March 14, 2002
PY-CEI/NRR-2614L

Perry Nuclear Power Plant
Docket No. 50-440
License Amendment Request Pursuant to 10 CFR 50.90: Inclined Fuel Transfer System (IFTS)

INCLINED FUEL TRANSFER SYSTEM

Attachment 3
 PY-CEI/NRR-2614L
 Page 1 of 3

Transfer Tube
 (FROM
 USAR Figure 9.1-19)

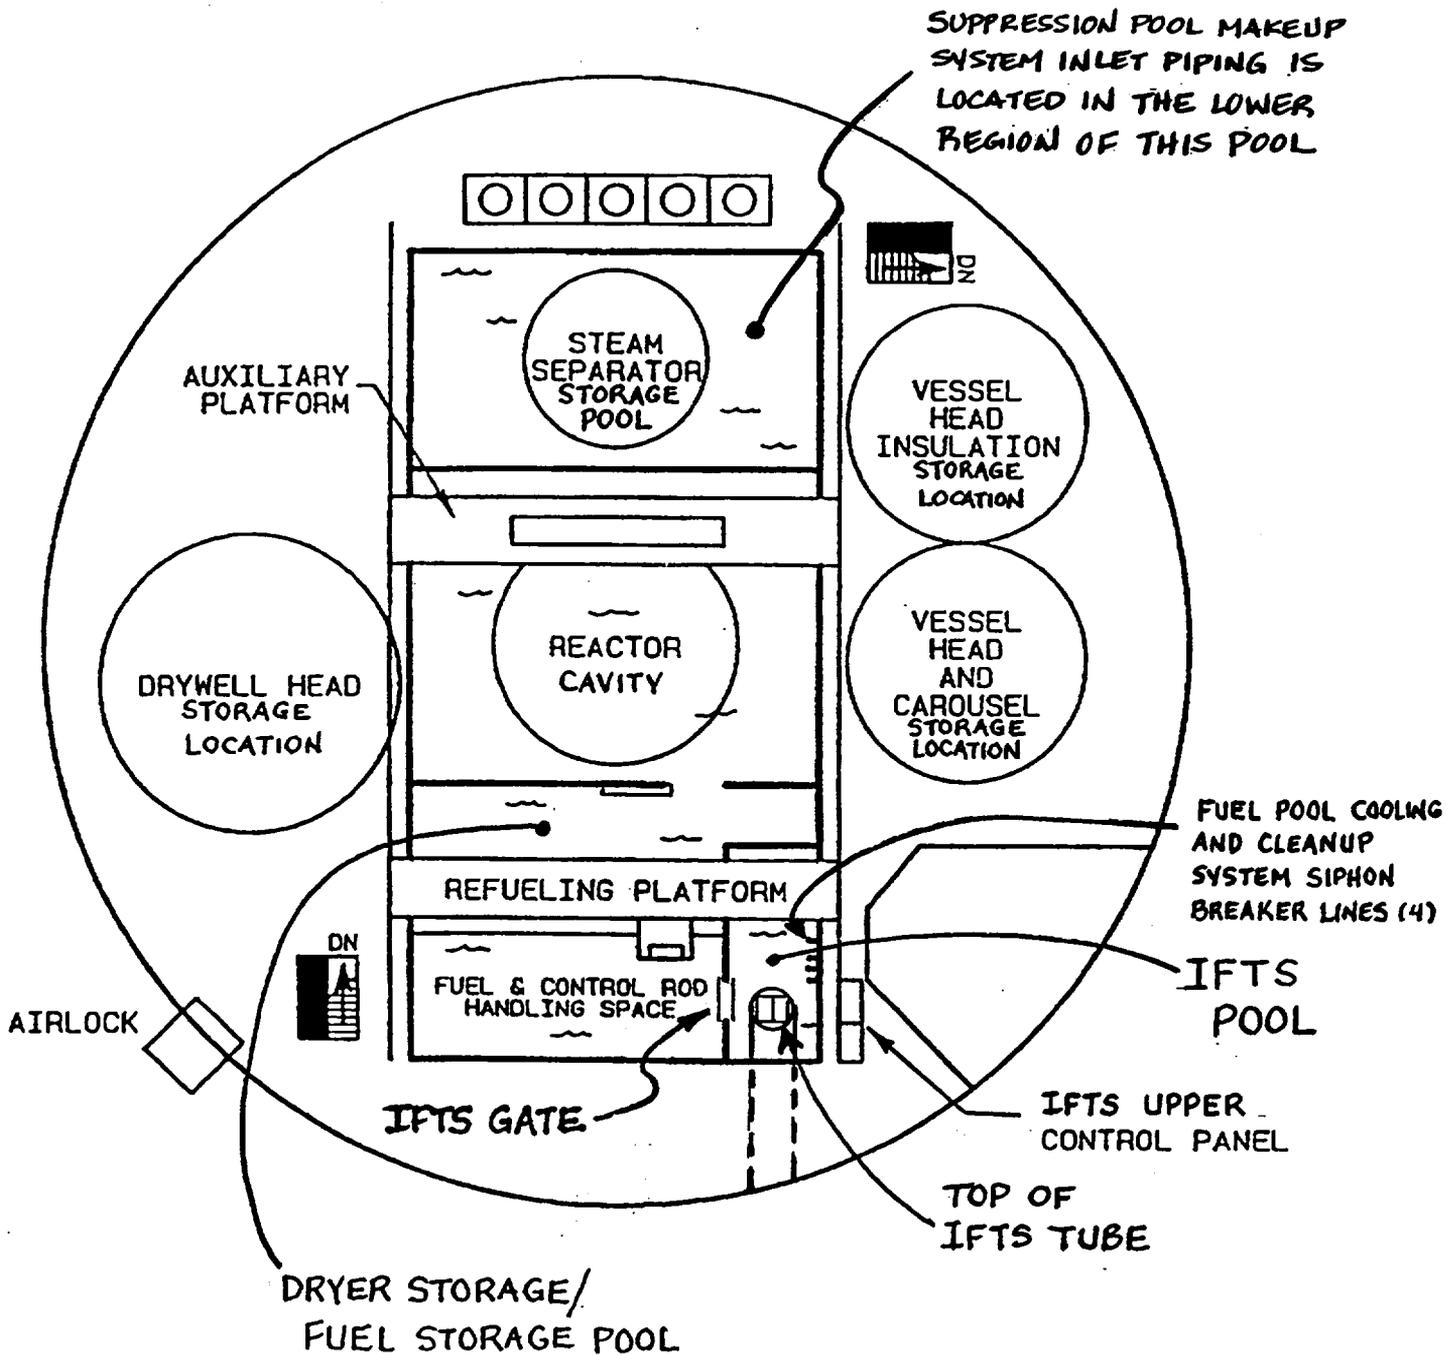
Review of the IFTS configuration with the blind flange removed reveals that several components (e.g., flap valve, IFTS tube, bottom valve, sheave box, fill valve, vent tube and the drain valve) may serve as a pressure boundary between the upper Containment pools and the Fuel Handling Building lower pools. These IFTS components are not safety related. They have been seismically qualified except for the flap valve and the sheave box.

As part of the input to this conservative analysis, a failure of the sheave box was modeled and flow to the drain tanks was not credited. Failure of the sheave box was conservatively modeled by postulating a circular opening equivalent to a hole of approximately 3 inches in diameter.

FROM USAR
FIGURE 9.1-26

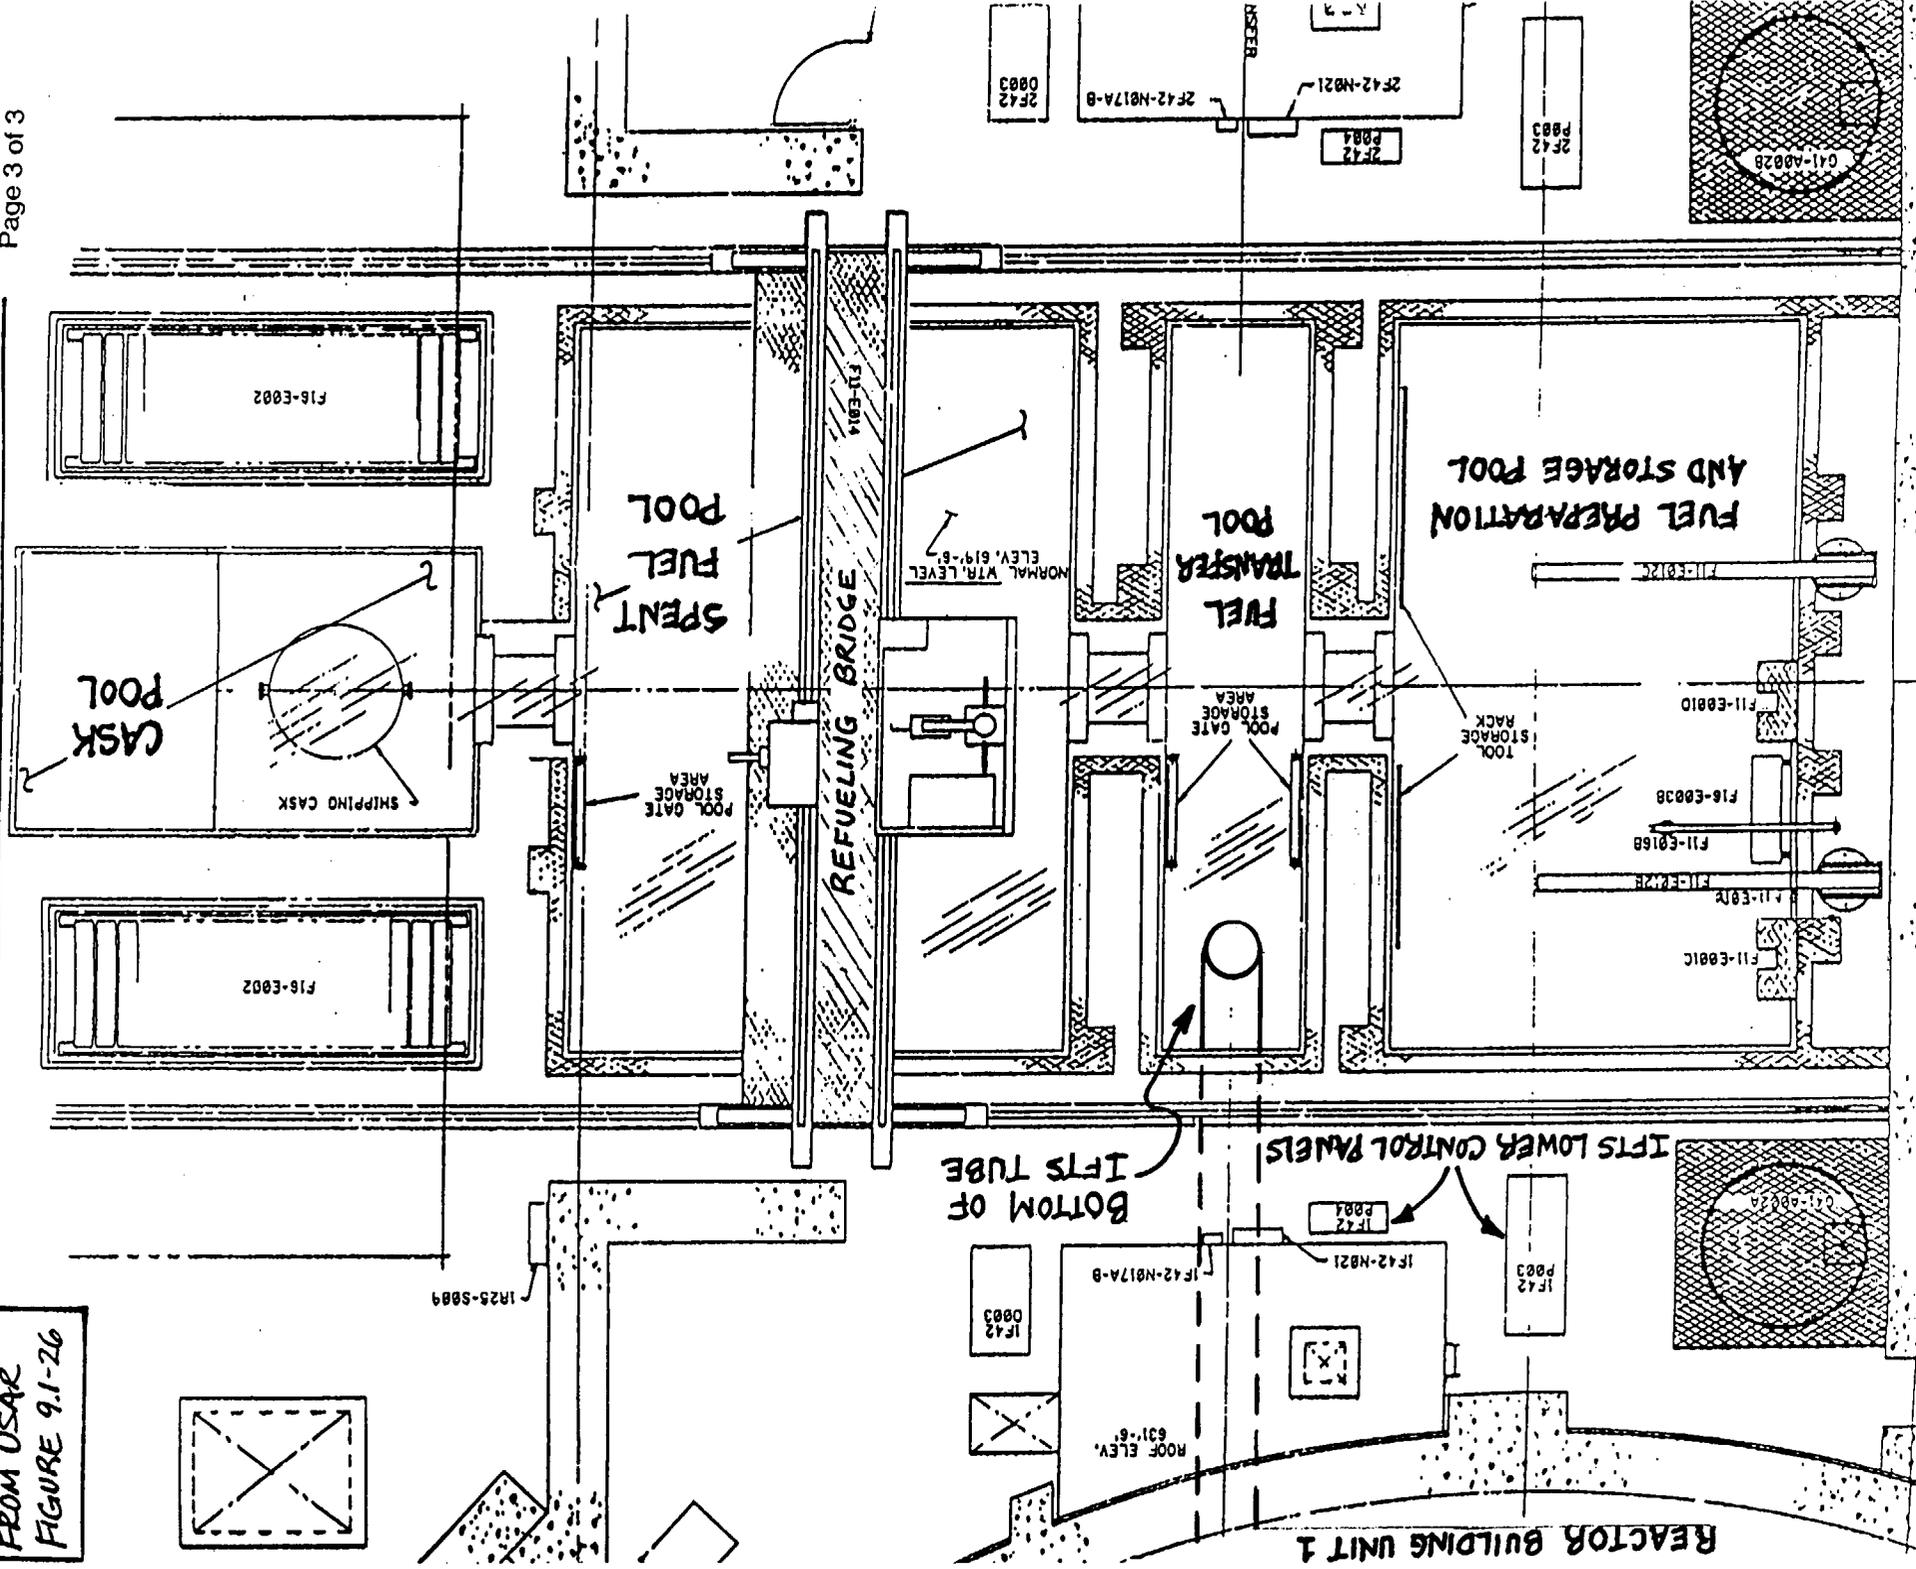
The SPMU system relies upon the water inventory from three sources (refer to the figure in Attachment 3, Page 2):

The lines that lead into the IFTS pool are 1" siphon breaker lines (reference page 2 of Attachment 3). These lines come off of the supply lines into the Reactor Cavity, the Dryer Storage/Fuel Storage pool and the Steam Separator Storage pool. The function of the four 1" siphon breaker lines is to break the vacuum of the Fuel Pool Cooling and Cleanup system supply water piping in the event of a supply pipe failure. Should the supply piping fail at a low elevation outside of the pool, the pump side of the break would discharge to the floor. However the poolside of the break, because of its low elevation would cause reverse flow or siphon of the pool volume through the normal supply to the pool. The safety related, seismic, siphon breaker lines serve to break this vacuum and minimize pool inventory loss, thus providing protection of the SPMU inventory.

The siphon breaker lines terminate in the upper Containment IFTS pool below the required SPMU water level. During a design basis LOCA, with a postulated component failure or a receipt of a spurious opening signal for one of the non-safety, non-seismic IFTS components, the upper IFTS pool would drain and as a result, the other upper Containment pools would potentially drain into the IFTS pool via the siphon breaker lines. This would lower the SPMU's available water inventory and may adversely impact its design function. To address this issue, a modification will be completed to extend the elevation of the affected Fuel Pool Cooling and Cleanup system siphon breaker lines that discharge to the upper IFTS Containment pool to above the minimum required SPMU level. This modification will be completed before the proposed LAR is implemented.

3. A modification will be completed to extend the elevation of the affected Fuel Pool Cooling and Cleanup system siphon breaker lines that discharge to the upper IFTS Containment pool to above the minimum required SPMU level. This modification will be completed before the proposed LAR is implemented.
